Serial: RNP-RA/07-0073

H. B. ROBINSON STEAM ELECTRIC PLANT, UNIT NO. 2  
DOCKET NO. 50-261/LICENSE NO. DPR-23

REQUEST FOR ADMINISTRATIVE CHANGES TO THE  
OPERATING LICENSE AND TECHNICAL SPECIFICATIONS

Figure 3.4.3-1  
Reactor Coolant System Heatup Limits  
Applicable Up to 35 EFPY

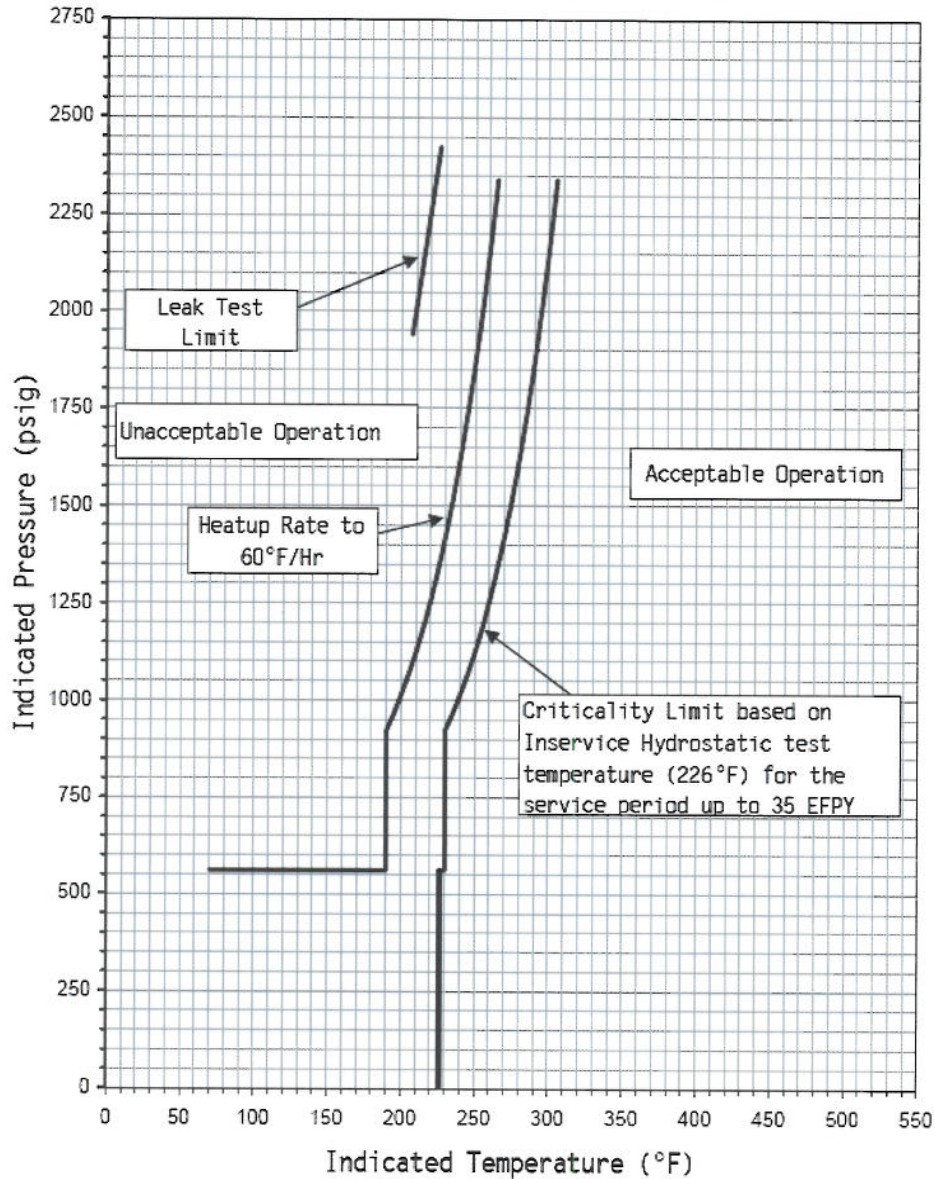
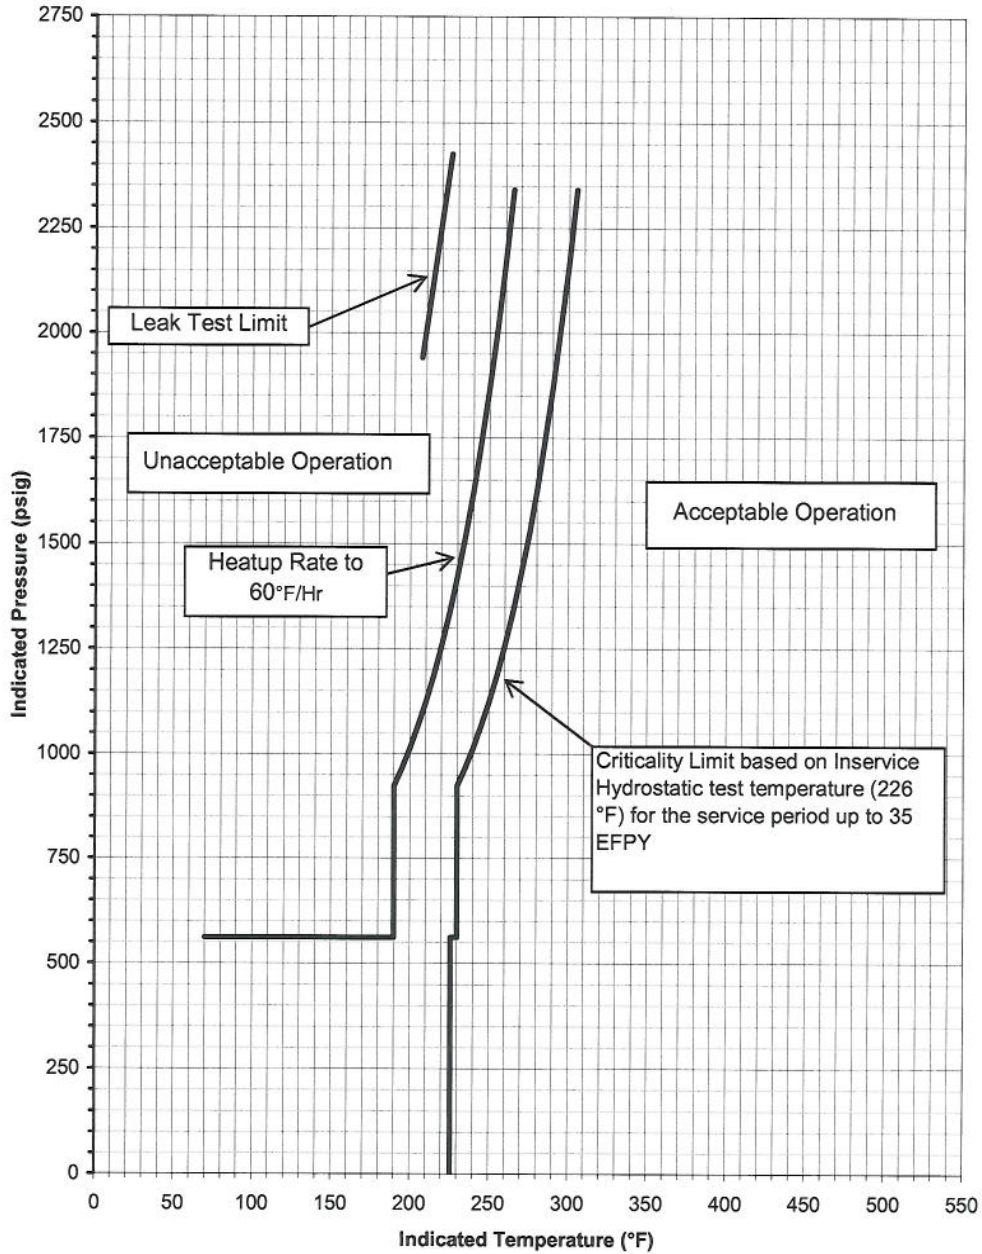
5. TS Section 3.4.3, "RCS Pressure and Temperature (P/T) Limits" – Figure 3.4.3-1 and Figure 3.4.3-2: When these figures were issued in Amendment No. 202 (NRC letter dated February 7, 2005 –TAC NO. MC4160), some information that was on the proposed figures (Progress Energy letter dated August 19, 2004) was inadvertently omitted or typed incorrectly. Specifically, in Figure 3.4.3-1, in the notes at the top, the Upper Shell Plate Weld ID (W10201-1) was omitted and the words "allowance" and "instrumentation" were typed with an uppercase "A" or "I" instead of lower case. In Figure 3.4.3-2, in the notes at the top, the Upper Shell Plate Weld ID (W10201-1) and the Girth Weld ID (10-273) were omitted, the limiting ART Values for 3/4T of 147°F and 172°F were omitted, and the words "allowance" and "instrumentation" were typed with an uppercase "A" or "I" instead of lower case. Additionally, in the graph, the identifier for the 60°F/Hr curve is missing the "Hr" term. These errors are being corrected.
